Technical Note TN-597
**Instruction for Modifying a
T201X Radio for
Fast PTT Response.**

2 November 1999

This Technical Note only applies to the logic board assembly
IPN 220-01377-03.

Fig. 1

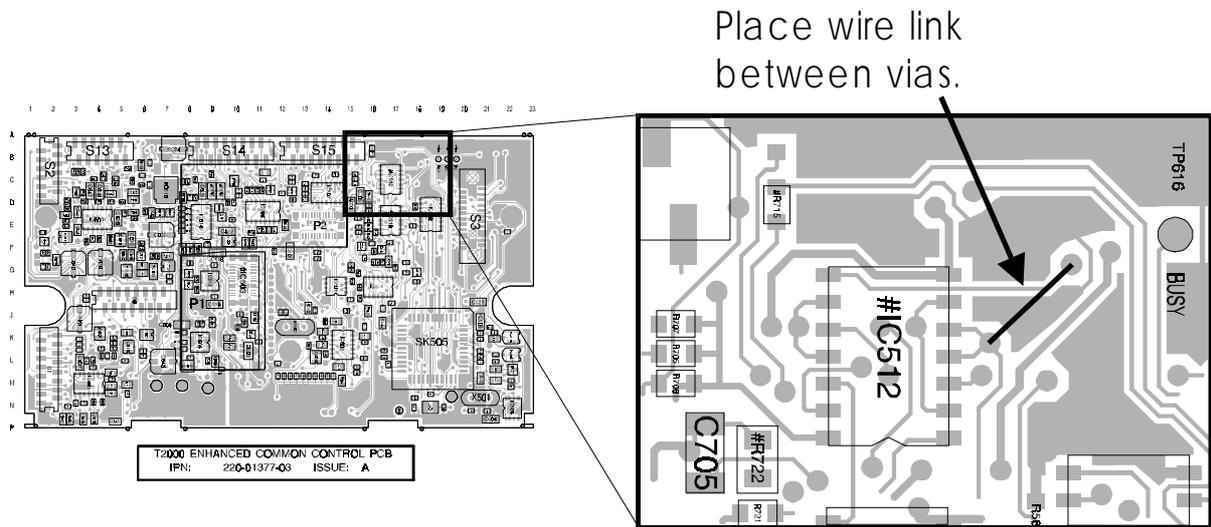
- 1) Fit a length of self flux link wire (IPN 200-00010-13) between vias as shown in Fig.1 below.
- 2) Install 1834a114 CSG firmware.
- 3) If the logic board previously had the R714 position (i.e. using V2.05 firmware), move R714 to the R715 position to allow the software to work.
